REMARKS

IN THE DRAWINGS

Annotated Marked-Up Drawings

FIG 5

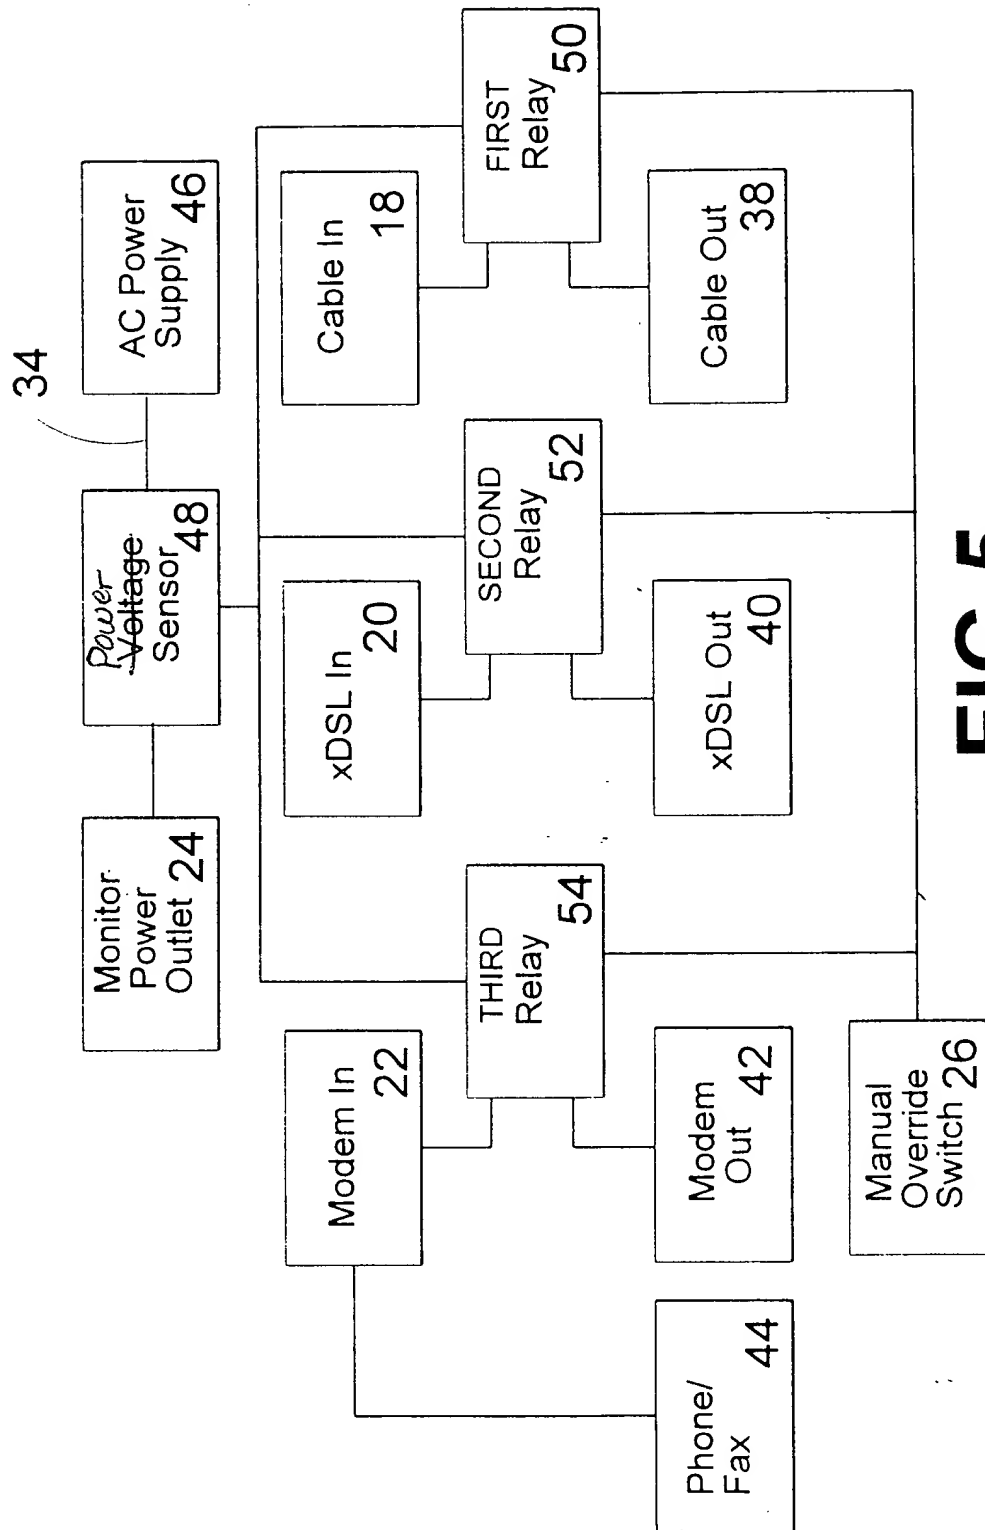
Figs. 5 and 6 are amended as shown in the attached replacement sheets. In Fig. 5, the label “Voltage Sensor” in item 48 is changed to “Power Sensor,” for reasons that will be discussed below in greater detail.

The use of the term voltage, with respect to sensor 48, throughout the specification is potentially confusing. In particular, electrical power is the product of the voltage and the current. Thus, power sensors typically include a voltage sensor, a current sensor, or both. However, in Fig. 5, voltage sensor 48 is shown coupled directly to AC power supply 46, which may give the incorrect impression that voltage sensor 48 is monitoring the voltage provided by AC power supply 46 (e.g., a wall outlet). Of course, the amount of power drawn by the monitor should not affect the voltage provided by AC power supply 46, unless the monitor tries to draw more current than the supply 46 can provide.

Changing the term “voltage” to “power” clarifies the specification, because the level of power drawn by the computer/monitor is what triggers the relay, regardless of whether the power consumption is determined by measuring voltage or current. Further, it is clear from Applicant’s original disclosure that this is the case. Note for example, in original Fig. 5, “AC Power Sensor 48.” Also, note Applicant’s original disclosure at Page 19, Lines 8-10, which provides: “In operation, the personal computer failsafe protection device 10 is connected to a monitor of a computer system or to a one piece computer system 56 **for measuring the amount of power being drawn thereby**” (emphasis added). Further, at Page 16, Lines 18-19, Applicant’s original disclosure provides: “A block diagram of the personal computer failsafe protection device 10 used **to sense the power usage of a monitor** is shown in Figure 5” (emphasis added). Thus, there is clear support in Applicant’s original disclosure for the clarifying amendments made herein.

Please amend Fig.5 and Fig. 6 by substituting the attached replacement sheets 5 of 6 (Fig. 5) and 6 of 6 (Fig. 6) for the originally filed sheets 5 and 6 of the drawings.
